Access Compliance Report

Public Rights-of-Way

Intersection ID: 43650	Main Street: CAMDEN_MEADOW_DR	Cross Street: BALLINDERRY_DR	Location: SE
ADA ID: EBDFOB0D8E295	Ramp Type: Perp	Initial Pass/Fail: Fail	Overall Compliance: No
Severity Score: 25			
Codes/Mitigation Info/Possible Solution		Field Measurements/Component Compliance

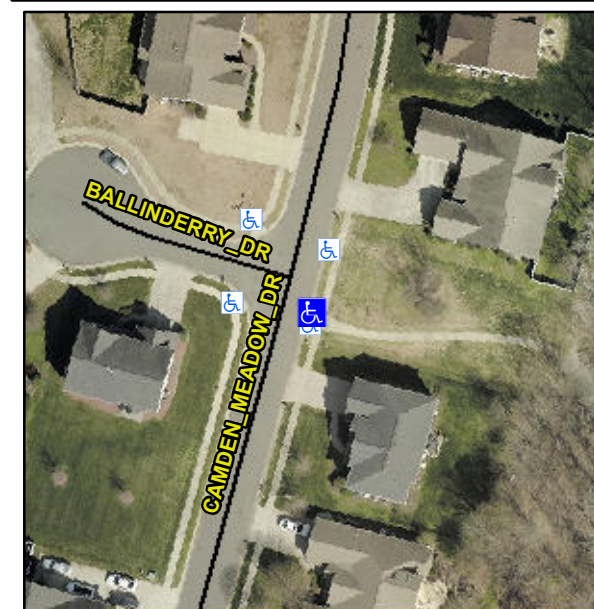
Not Found, R304.2.2

Compliance	Description	Data	Compliance	Description	Data
N/A	Ramp Length (in)	47.0	No	Ramp Slope (%)	12.3
Yes	Ramp Width (in)	49.5	Yes	Ramp XSlope (%)	1.6
N/A	Flare Type LT	N/A	N/A	Flare Type RT	N/A
N/A	Flare Slope LT (%)	N/A	N/A	Flare Slope RT (%)	N/A
N/A	Flare Traversable LT?	N/A	N/A	Flare Traversable RT?	N/A
N/A	Landing Length (in)	N/A	N/A	DWS Provided?	N/A
N/A	Landing Width (in)	N/A	N/A	DWS Contrast?	N/A
N/A	Landing Slope (%)	N/A	N/A	DWS Length (in)	N/A
N/A	Landing X Slope (%)	N/A	N/A	DWS Full Width?	N/A
N/A	Landing Curb? (Y/N)	N/A	N/A	DWS Offset (in)	N/A
N/A	Shared Landing?	N/A			
N/A	Gutter Ponding?	N/A	N/A	Gutter Slope (%)	N/A
N/A	Gutter Lip Ht (in)	N/A	N/A	Gutter X Slope (%)	N/A
N/A	Painted X Walk1?	No	N/A	Painted X Walk2?	N/A
	X Walk 1 Direction	To W		X Walk 2 Direction	N/A
N/A	X Walk 1 Width (in)	N/A	N/A	X Walk 2 Width (in)	N/A
	X Walk 1 Slope (%)	4.5		X Walk 2 Slope (%)	N/A
	X Walk 1 X Slope (%)	1.9		X Walk 2 X Slope (%)	N/A

Remove & Replace Entire Ramp.
